FED. ROAD DIST. NO.	STATE	PROJ. NO.	FISCAL YEAR	SHEET NO.	TOTAL SHEETS
HAWAII	HAW.	139A-01-05M	2005	ADD.52	106

6/07/07	Replace with updated version, per Addendum No. 1.
---------	---

STATE OF HAWAII DEPARTMENT OF TRANSPORTATION HIGHWAYS DIVISION
<u>CURB RAMP AND SIDEWALK NOTES</u>
<u>OLD KEAAU-PAHOA ROAD RESURFACING</u>
<u>KEAAU TO KEAAU HIGH SCHOOL</u>
<u>PROJECT NO. 139A-01-05M</u>
Date: Nov., 2004

**TYPICAL SIDEWALK
CULVERT DETAILS**

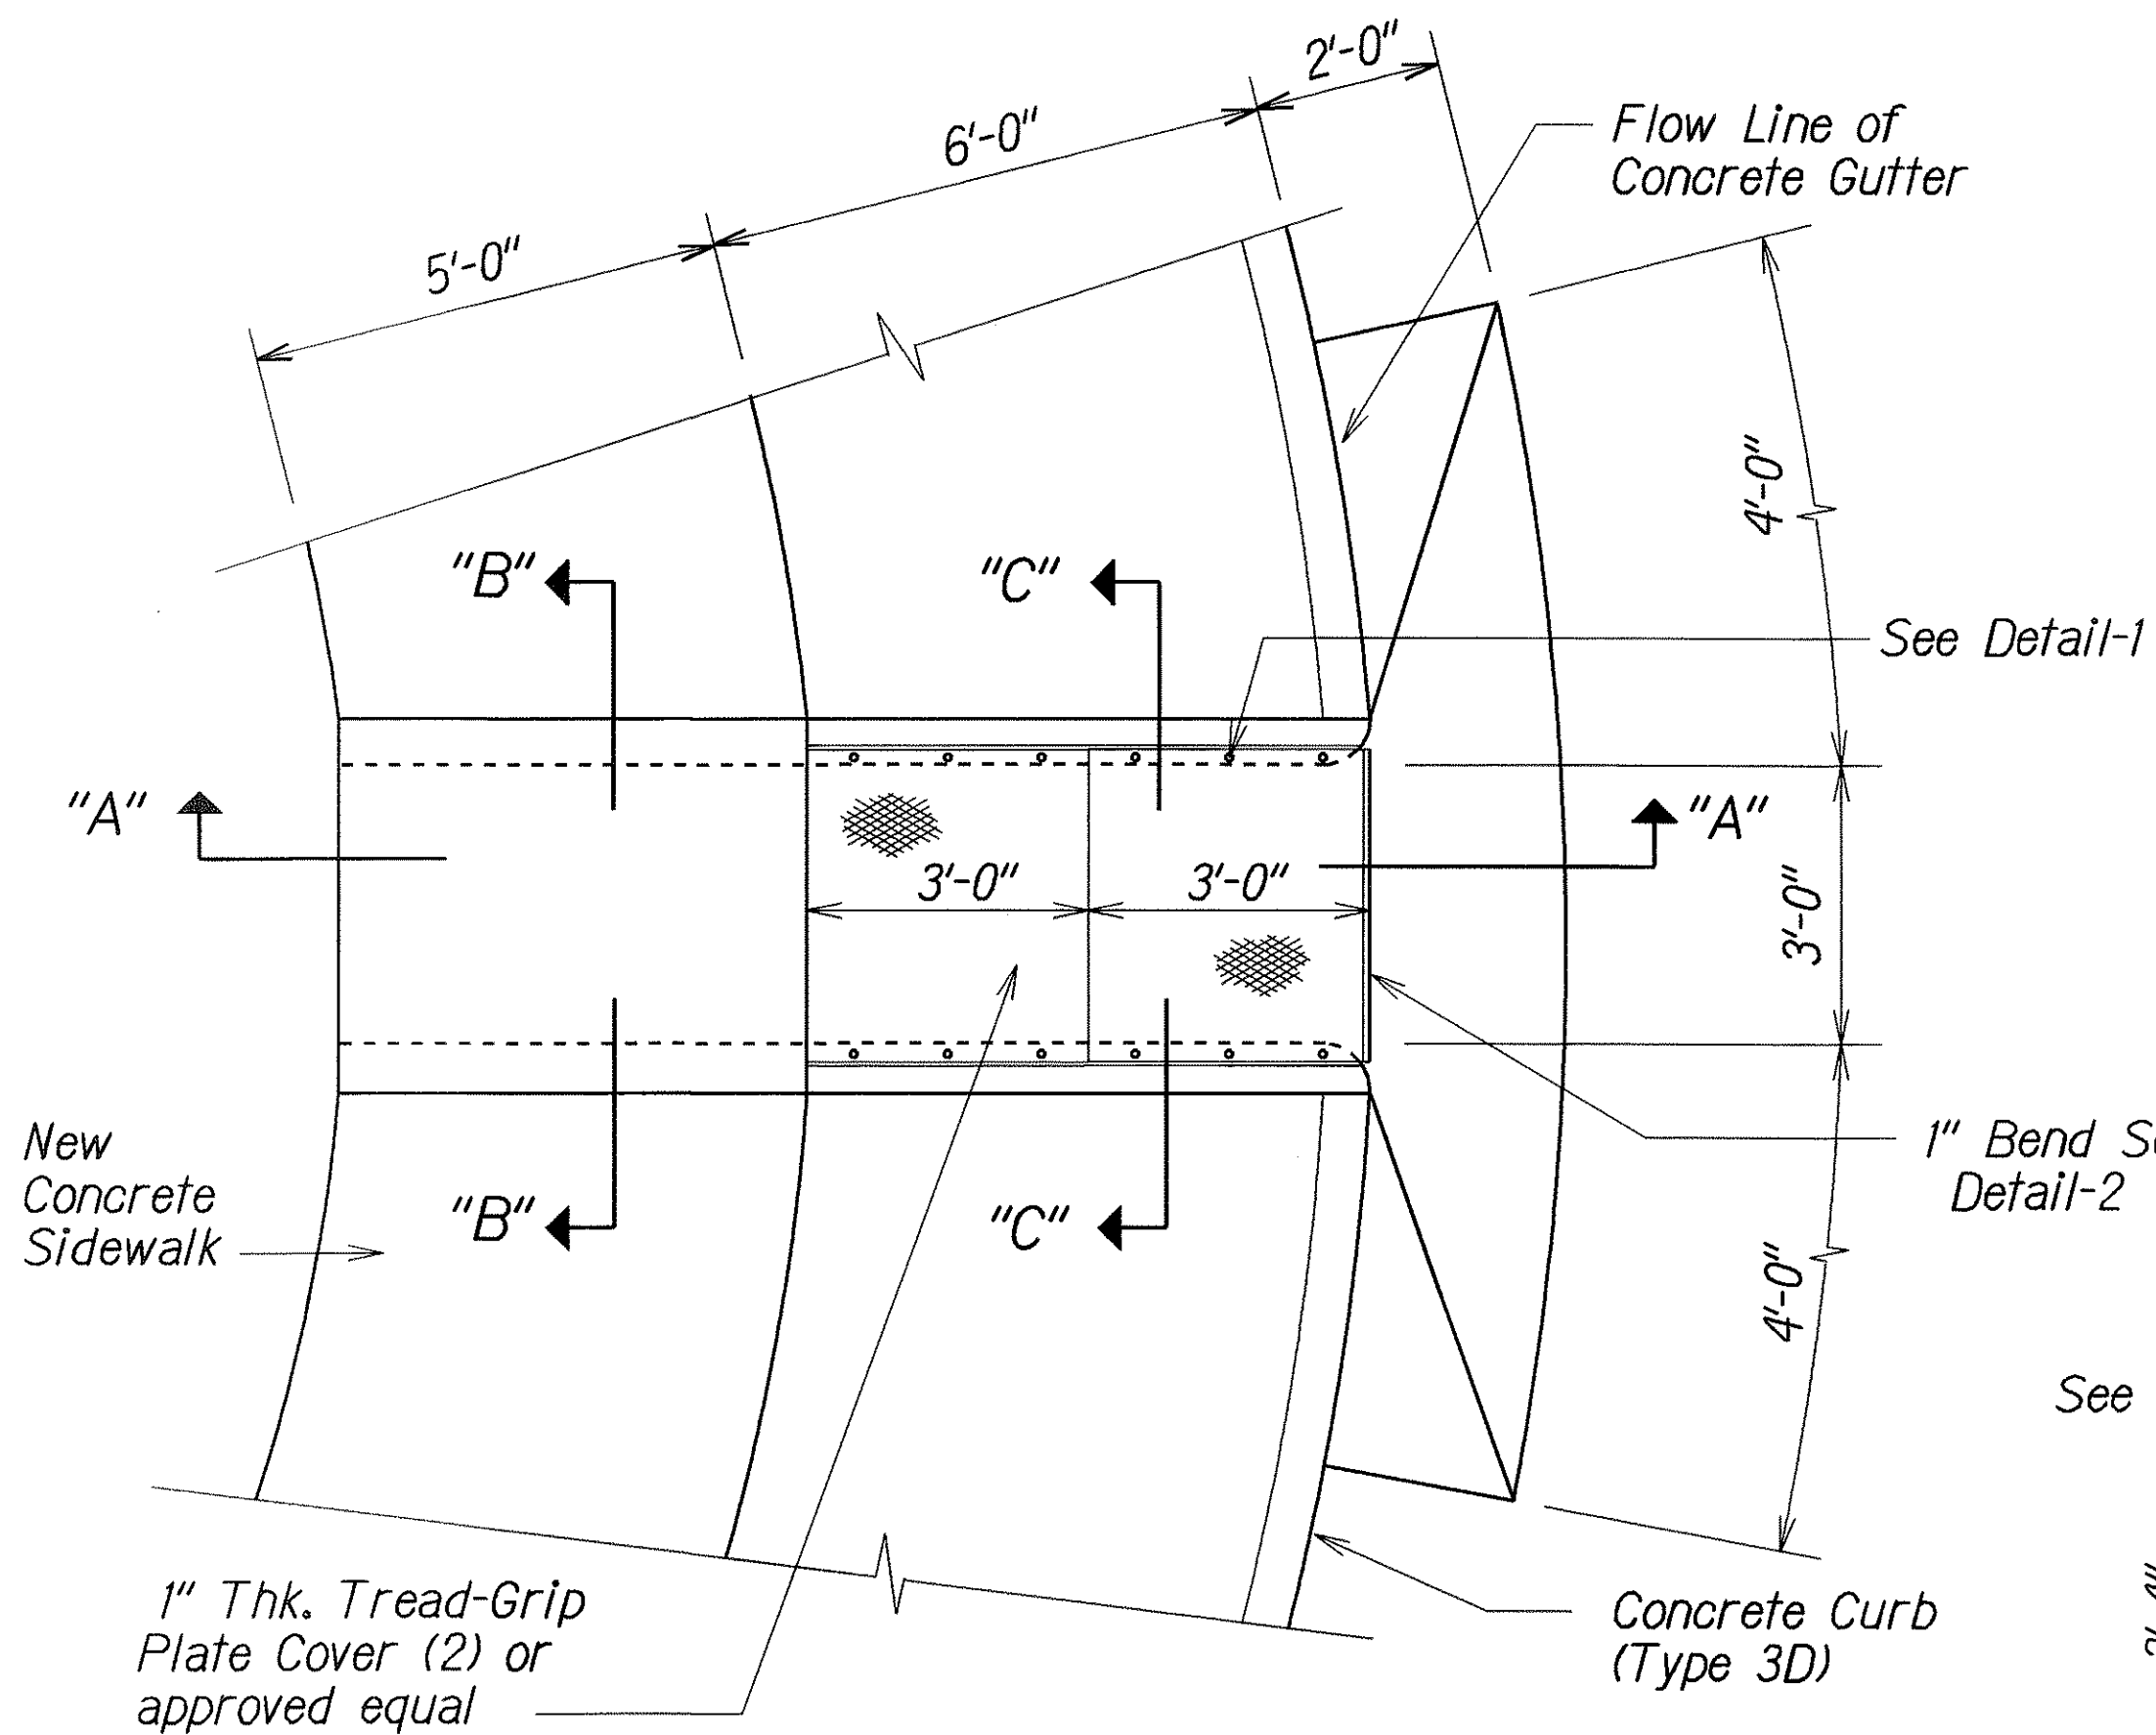
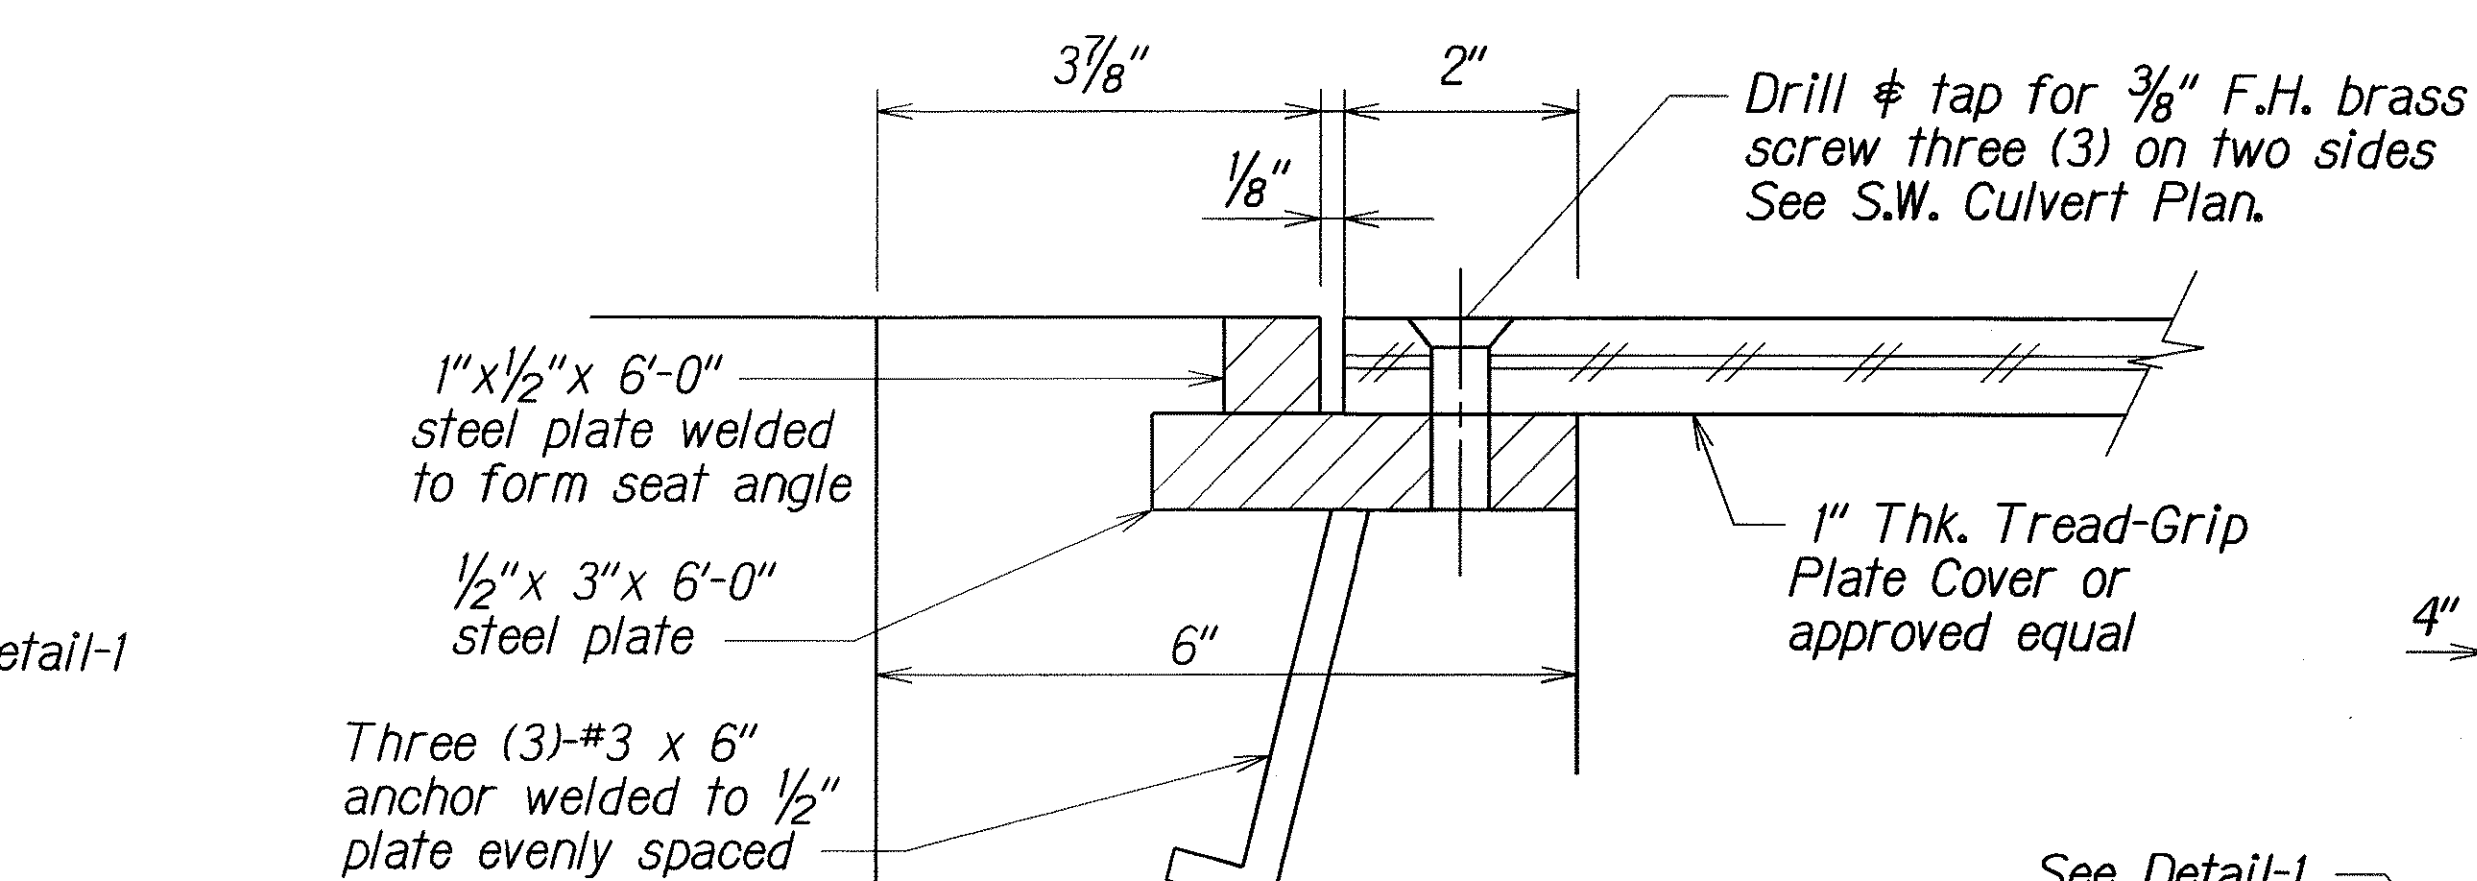
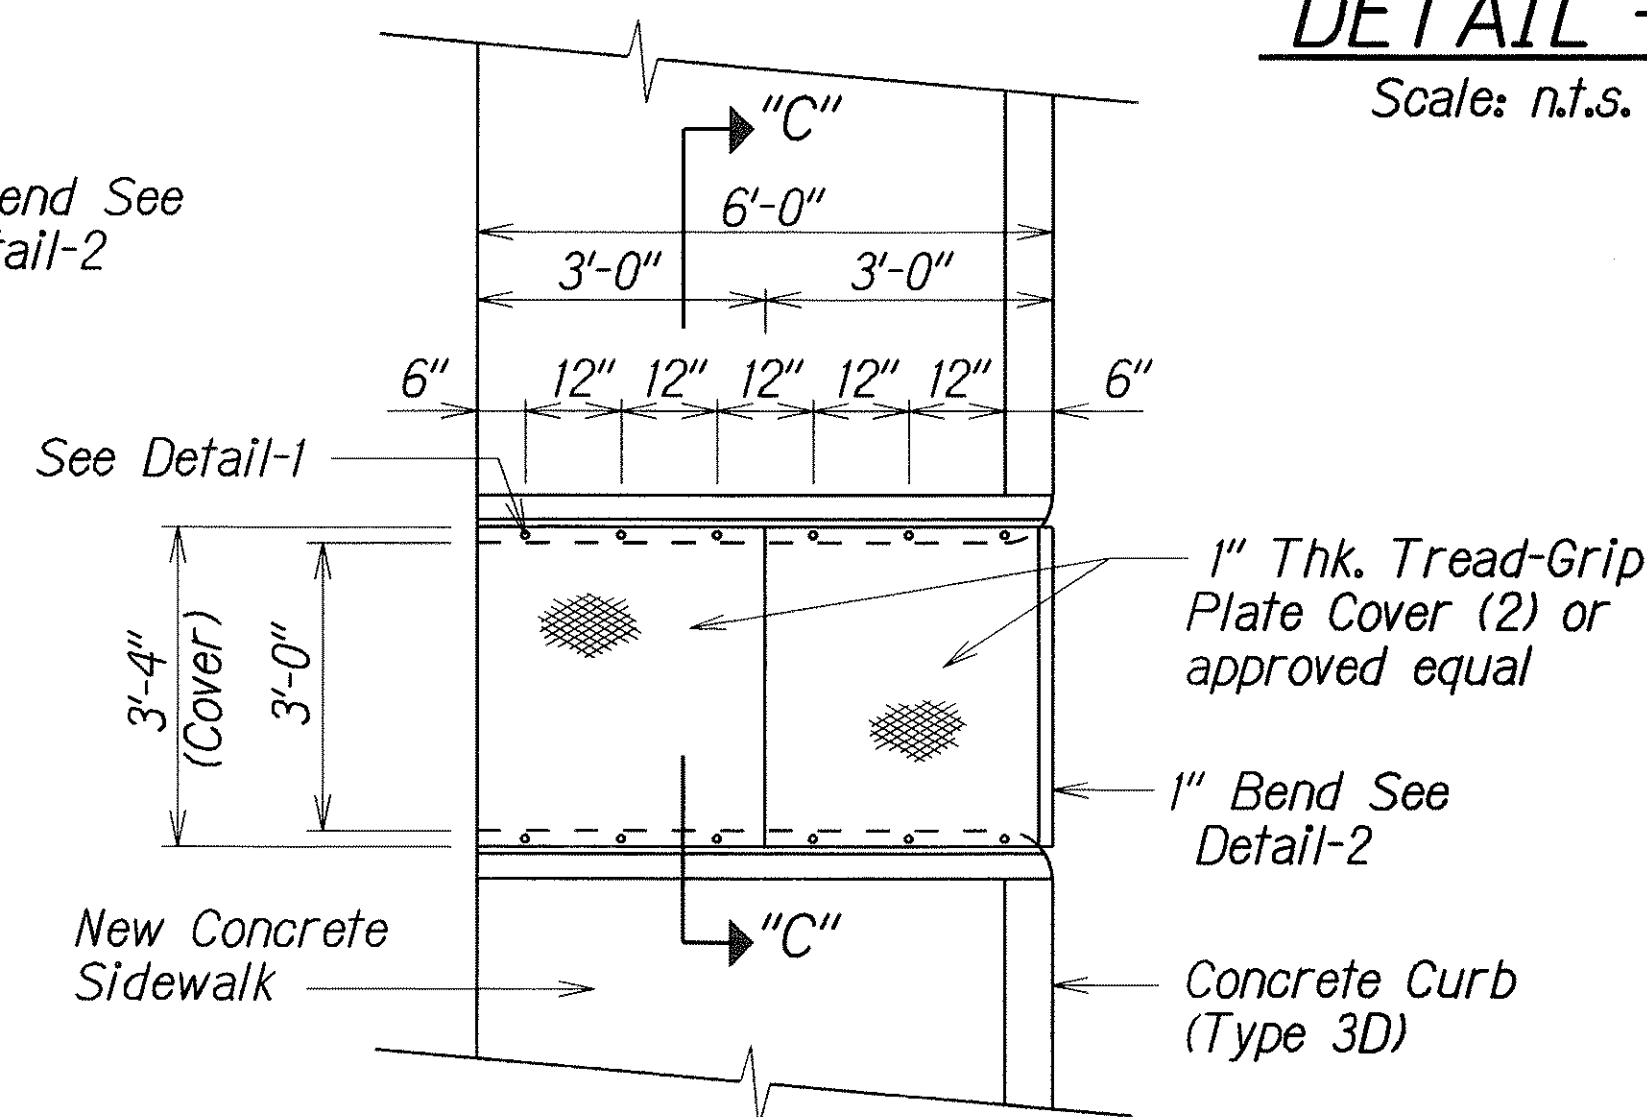
6/07/07 Revise culvert details and notes, per Addendum No. 1.
